Docket: NRC-2012-0192

Application and Amendment to Facility Operating License Involving Proposed No Significant Hazards Consideration Determination

Southern California Edison, San Onofre Nuclear Generating Station, Units 2 and 3; Application and Amendment to Facility Operating License Involving Proposed No Significant Hazards Consideration Determination

Organization: Citizens Oversight Projects (COPS)

San Onofre Nuclear Generating Station Exclusion Zone

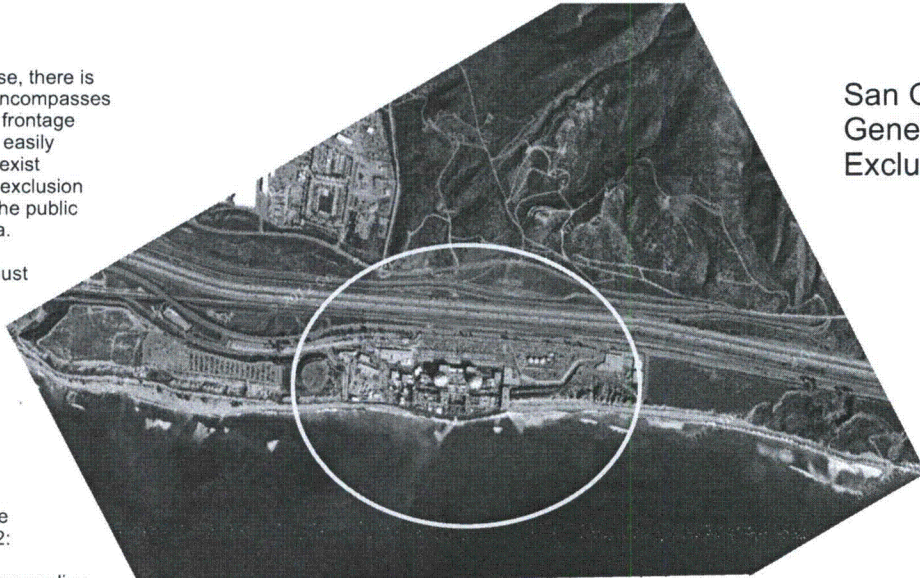
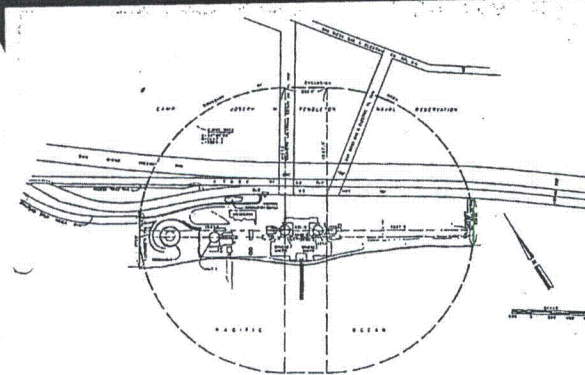
=====
--> The exclusion zone at San Onofre Nuclear Generating Station includes a freeway and an accessible beach. There are no signs warning people that ingress to the area may subject them to

---> Contrary to the definition of an exclusion zone, there is no means to stop traffic on the freeway in the event of a SGTR or LOCA, events that can progress within minutes and may require the complete shutdown of the freeway. Licensee should be required to install gates and turn-arounds to allow that traffic be completely stopped on the freeway and rerouted to other roads.

According to the San Onofre license, there is an exclusion area defined which encompasses a large section of the freeway, the frontage road, and the beach area which is easily accessible to the public. No signs exist informing the public that this is an exclusion area and concern for radiation to the public occurs at the boundary of this area.

The license also says that there must be a way to control traffic on the roads next to the plant but there is no control to this area of the freeway that I have seen. I would think they would have to install lights and gates at the previous overpass so cars can be easily stopped and turned away.
